**1958 Agreement – Consideration of draft amendments
to existing Regulations submitted by GRSP**

Proposal for Supplement 2 to the 02 series of amendments to Regulation No. 29 (Cabs of commercial vehicles)

Submitted by the Working Party on Passive Safety *

Annex 3, Appendix 2,

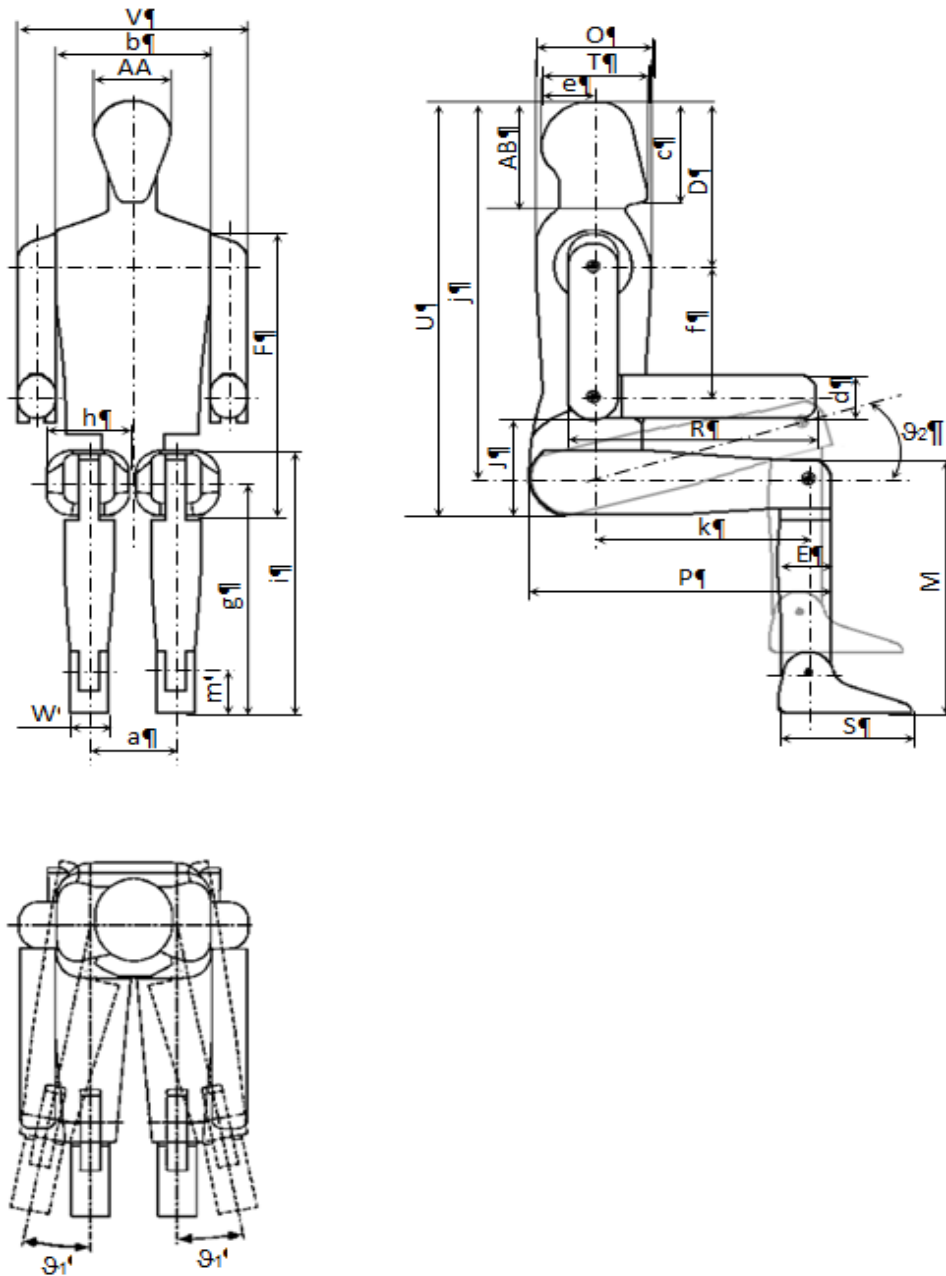
The figure, amend to read:
